UNITED STATES PATENT AND TRADEMARK OFFICE

APPLICATION NO.	FILING DATE	FIRST NAMED INVENTOR	ATTORNEY DOCKET NO.	CONFIRMATION NO.
10/724,275	11/26/2003	Douglas Allard	11533.0028.NPUS00	8914

Office Action Summary

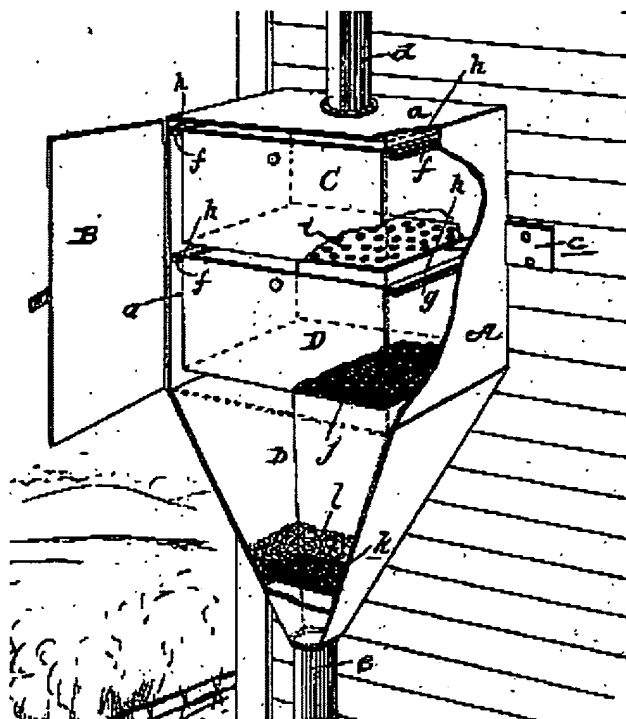
5. Claims 1-7, 10, 19-23, 29-32 and 40-43 are rejected under 35 U.S.C. 102(b) as being anticipated by Buckley (U.S. 0,543,922).

Buckley teaches a downspout filter apparatus that discloses all the limitations of claims 1-7, 10, 19-23 and 29-32 including a plurality of filters each having filter elements or screens. Filters Drawers C and D are considered by the examiner to be "cartridges". An outer housing A is provided about the cartridges. In operation, rainwater from a downspout is filtered while flowing through the plurality of filters and the filtered water returns to the

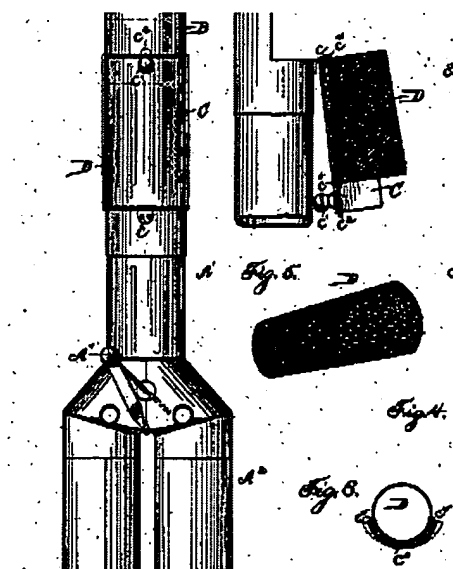
6. Claims 1-3, 5-7, 10, 14-15, 18-21, 23-24, 29-32, 36 and 39-44 are rejected under 35 U.S.C. 102(b) as being anticipated by Minnemeyer.

Minnemeyer teaches a filter in a downspout from an eave. A diverter A³ directs the filtered rainwater either to the outlet or to a second outlet leading to a cistern. As shown in the drawings the rest of the limitations of the aforementioned claims are met.

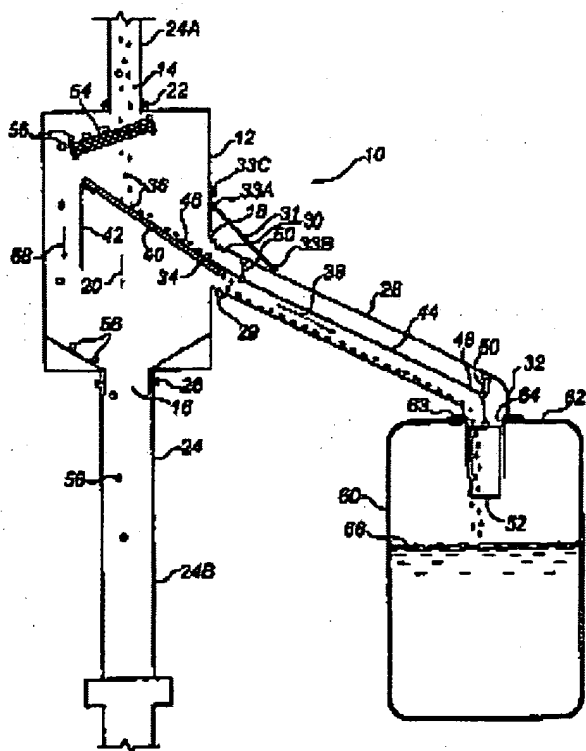
7. Claims 1-2, 5-7, 10-12, 19-20, 23, 29-30, 33-34, and 40-43 rejected under 35

U.S.C. 102(b) as being anticipated by Huppert (U.S. 3,628,668).

Huppert teaches a filter including a screen element 6 positioned between the inlet 3 and outlet 17 of a downspout. A primary bypass passageway is provided via aperture 5 and apertures 10, as in the aforementioned claims.

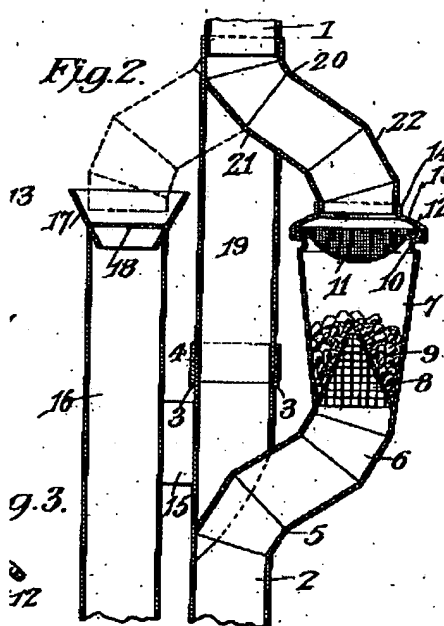
9. Claims 1-2, 4-7, 10-16, 19-20, 22-23, 25-26, 28-30 and 33-37 are rejected under 35 U.S.C. 102(b) as being anticipated by Walker (U.S. 971,578).

Walker teaches a downspout filter apparatus. The apparatus is considered by the examiner to include pipes 16, 19 and 6 (19 and 16 are joined by 15) connected between an inlet 1 and a plurality of outlets. A plurality of filters are disclosed including 11, 9, 8, & 18. Flow paths 16 and 19 are considered to be primary and secondary bypasses providing alternate routes through the apparatus. Each pipe is disclosed to provide either drinking water or water for other uses (separate destinations). See page 2, lines 35-47.
